Job Number: 190021
Date: 18th August 2020

Re: Response to Northside Private Hospital, West Gosford (SSD-10159) – Review of Environmental Impact Statement, 24th March 2020

Figure 1: Extract flood map 2019 flood study, yellow circle = subject site location

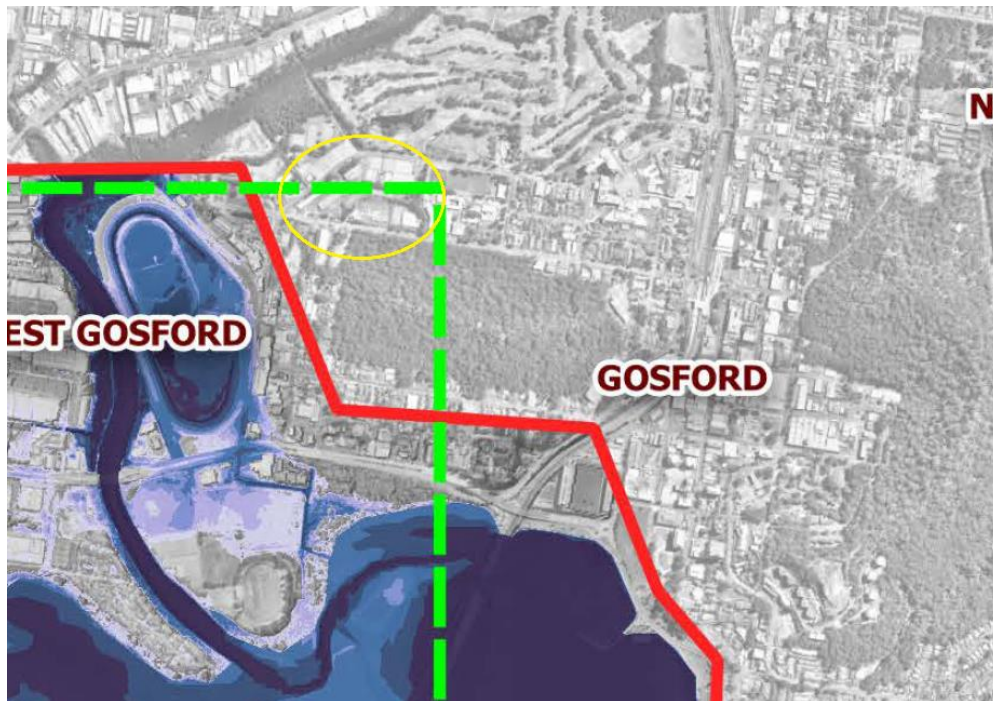
The EIS has not considered the Gosford CBD Local Overland Flow Flood Study (Sept 2018) prepared by Cardno Lawson Trelaor.

An overland flow of up to 500mm through the site is identified in that study. The proponent has not considered how this flooding will affect the proposed development or how the development could change flooding patterns and affect adjoining areas. The flood impact assessment should also address how flooding to the proposed below ground carpark will be managed.

Firstly we want to clear up what seems to be a misunderstanding. The letter refers to a 2018 flood study. The pertinent flood studies are:

- Gosford CBD Local Overland Flow Flood Study (18 September 2013)
- Brisbane Water Estuary Catchment Overland Flood Study (2019)

The 2019 study does not address our study area (see figure below).

As such the applicable study is the 2013 flood study, we used in our work dated 29th March 2019. As per that report the flood extent shown indicates a minor amount of ponding in areas away from areas of actual works. Hence our indication in our report from 29th March 2019 that no impacts are expected.

Your letter from 24th March 2020 indicates that you want further information referring to the 2018 study. As per above there is no such other study. We have used the best available information. Based on this a minor amount of ponding occurs and this will not be impacted by the development.
